Avasat LLC Property | +/- 41.84 Gross Acres  
 4910 State Route 257 S, Delaware, Ohio 43015  
 (Concord Township, Delaware County, State of Ohio)  
 Parcel Nos. 500-320-02-016-000 and 500-320-02-017-000

**RE: Disposition of Comments for Stallion Ranch TIS submittal dated 3/18/24**

The Stallion Ranch TIS was submitted on March 18, 2024. ODOT District 6 provided comments on May 3, 2024. The comments are provided below, followed by the Carpenter Marty Transportation (CM) response in red.

**RE: Results of the Emerald Farms Traffic Study (4910 State Route 257)  
Traffic Access Study (TAS)**

## Sight Distance Exhibit

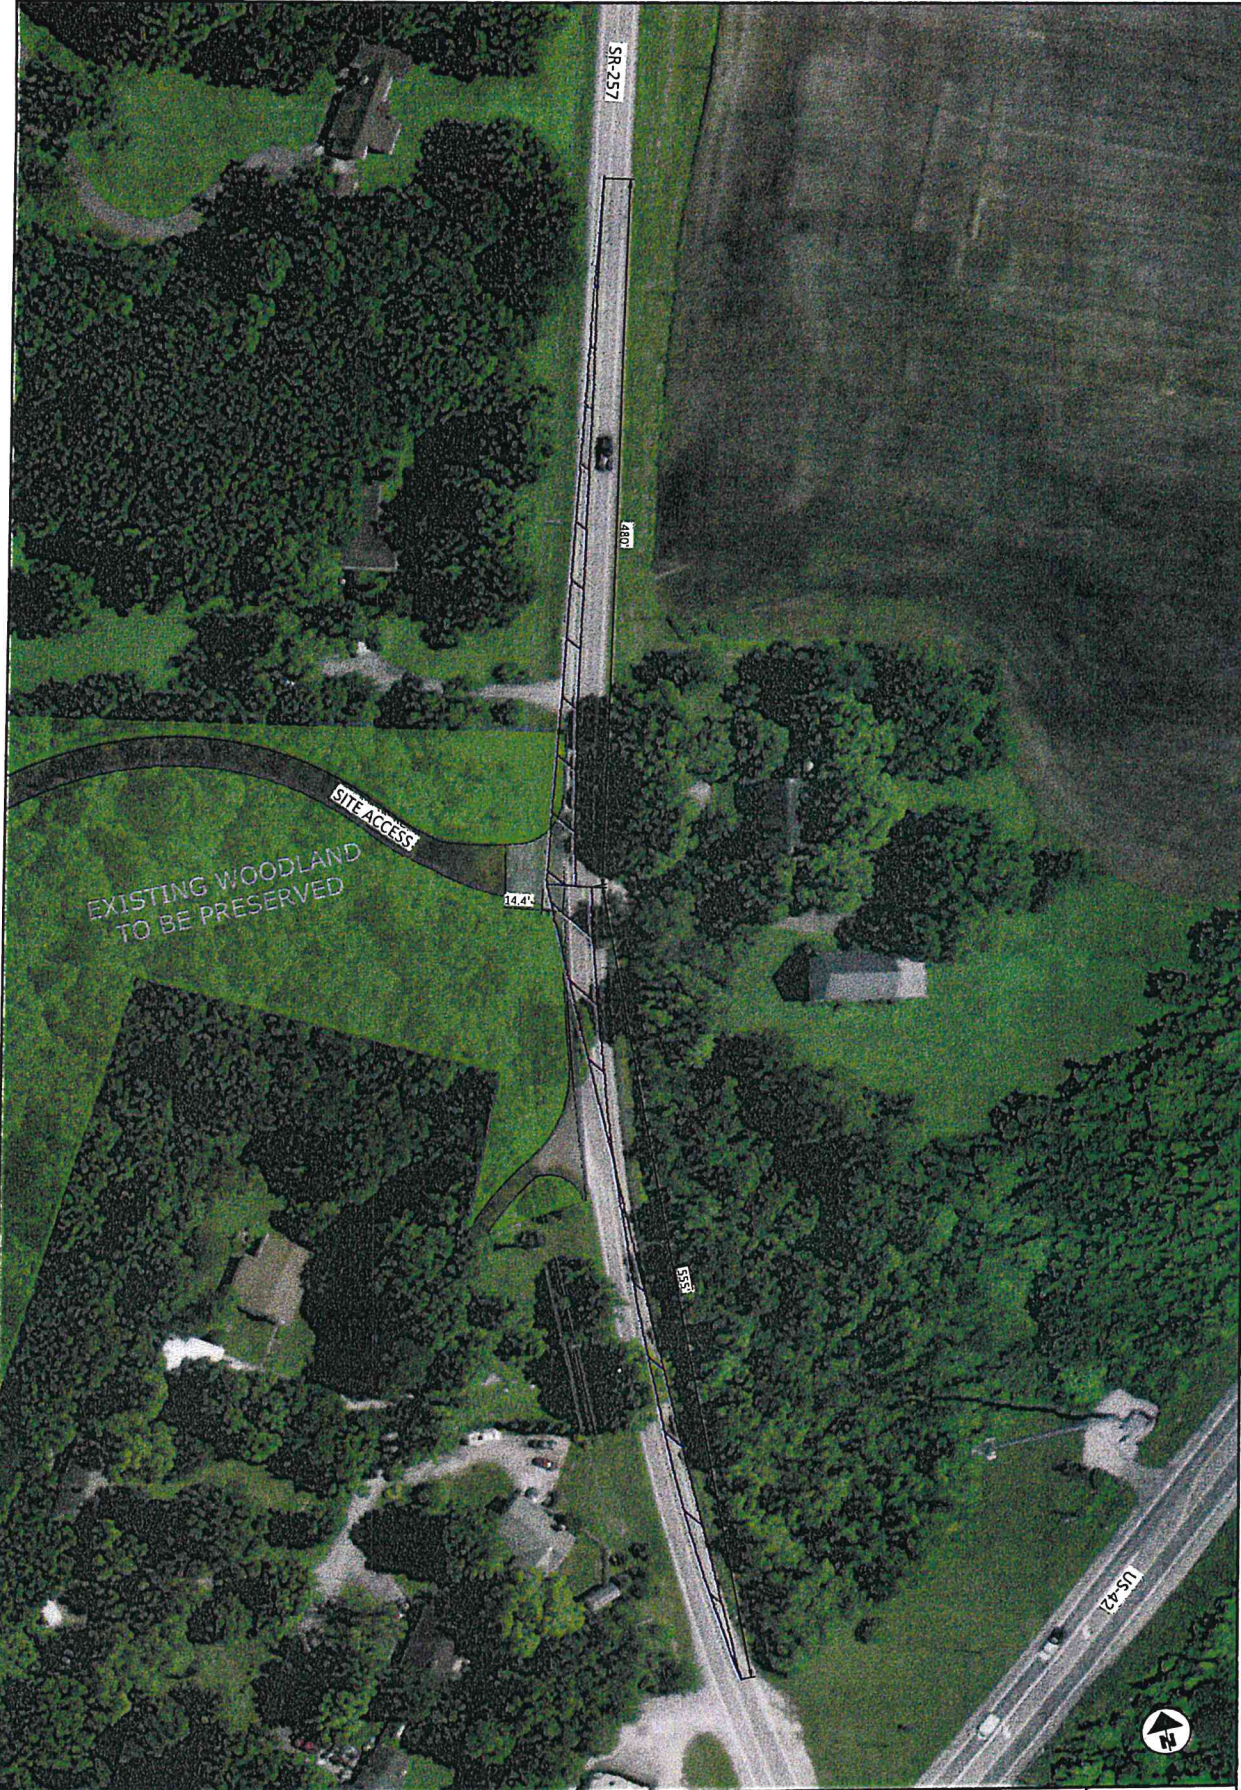
**CM Response: Updated.**
- 6) Update the turn lane warrant labels to Entry/Exit instead of AM/PM.  
**CM Response: Updated.**
- 7) Provide a sight distance drawing at the proposed drive.

6. Update the turn lane warrant labels to Entry/Exit peaks instead of AM/PM.
7. Provide a sight distance drawing at the proposed drive.

**CM Response: Complied.**

The sight distance analysis shows that the sight lines for vehicles exiting the site are not expected to be obstructed. The sight distance exhibit can be found in **Attachment E**.
